AGENDA REPORT SUMMARY

Meeting Date: June 11, 2019

Subject: Proposed Three-Story Mixed-Use Building at 385-389 First Street

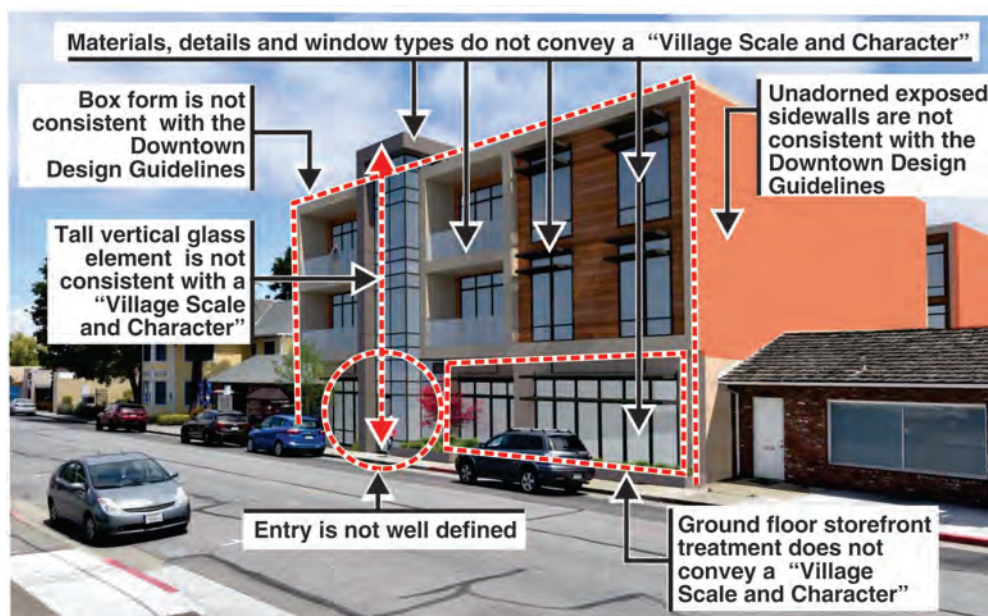
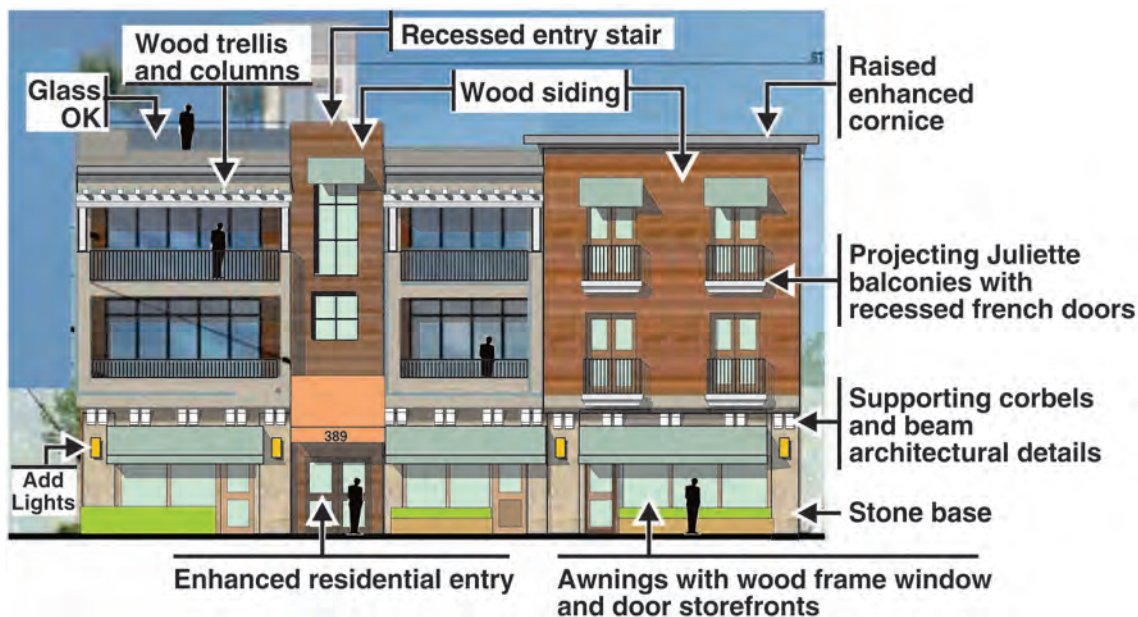
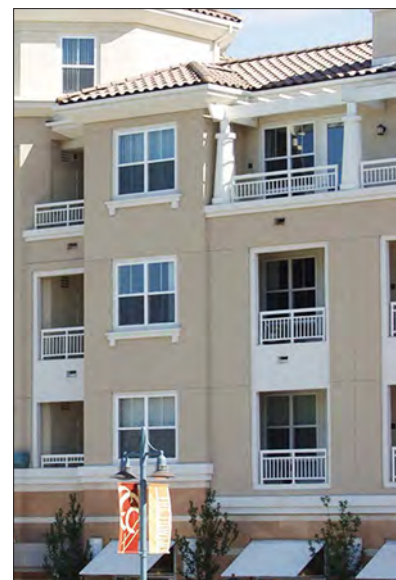
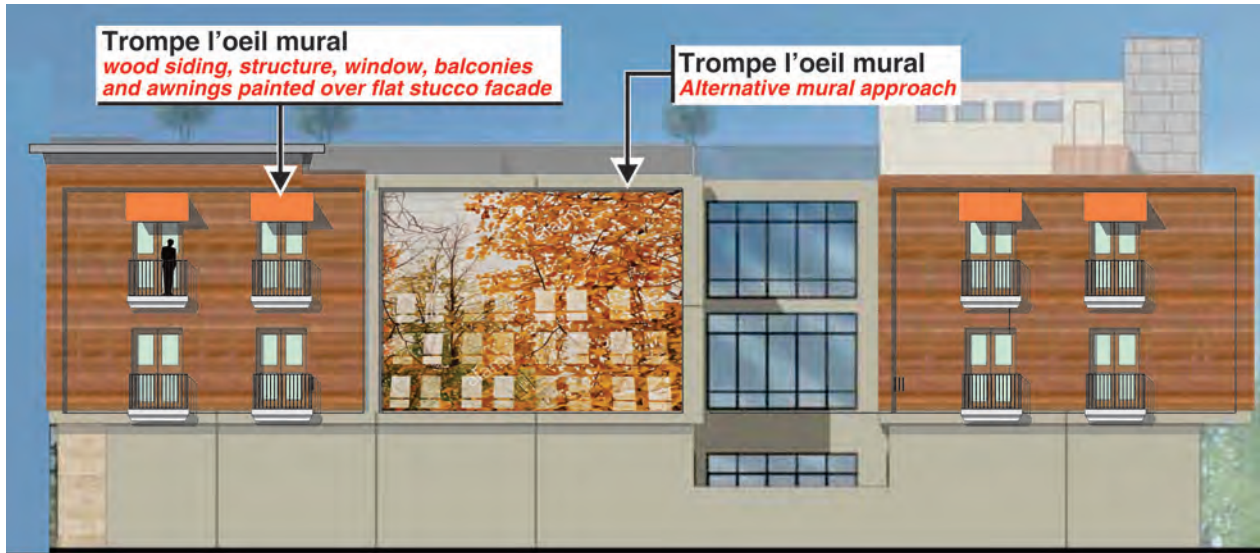
1. The overall building form is rather boxy and not consistent with a “Village Scale and Character”.
2. The tall glass element at the stair on the front facade is not consistent with a “Village Scale and Character”.
3. The residential entry is not well defined.
4. The ground floor storefront treatment does not convey a “Village Scale and Character”.
5. The materials, details and window types do not convey a “Village Scale and Character”
6. The unadorned exposed sidewalls are not consistent with the Downtown Design Guidelines. While these walls may be covered by adjacent new development sometime in the future, they may remain full exposed to view for many years to come.

1. Add parapet height and detail variety by a raised cornice on the right hand portion of the front elevation and lowering the perceived parapet height to the left by adding open trellises on the top floor in lieu of the currently proposed solid canopy. The use of the wood trellis and columns would also reduce the visual height of that part of the structure - see example photo to the right.
2. Recess the front facade at the entry, as suggested by planning commissioners in their study session.
3. Use wood siding on the upper floor facades and on the stair tower facade.

5. Use awnings on the first floor and selected upper floor windows. This would add human scale to the facade and provide a strong link between the upper floor residential and the pedestrian level - see example photos below.

9. Use stone on the building base.

I included wood as the primary wall material on the illustration on page 6 since several commissioners expressed interest in that approach to add some warmth to the structure. The result in the above illustration would be a breaking of the building mass into two smaller segments. However, another approach would be to stick with stucco for the upper floors, as shown in the diagram below.

10. For the blank side walls, there are a couple of approaches that could be considered. In a recent project that I reviewed in the San Mateo Downtown, we worked with the applicant to treat a similar blank wall by wrapping the front facade materials and design pattern around on the blank wall with much less plane depth change than utilized on the other facades. This was combined with an art mural - see sketch illustration below.
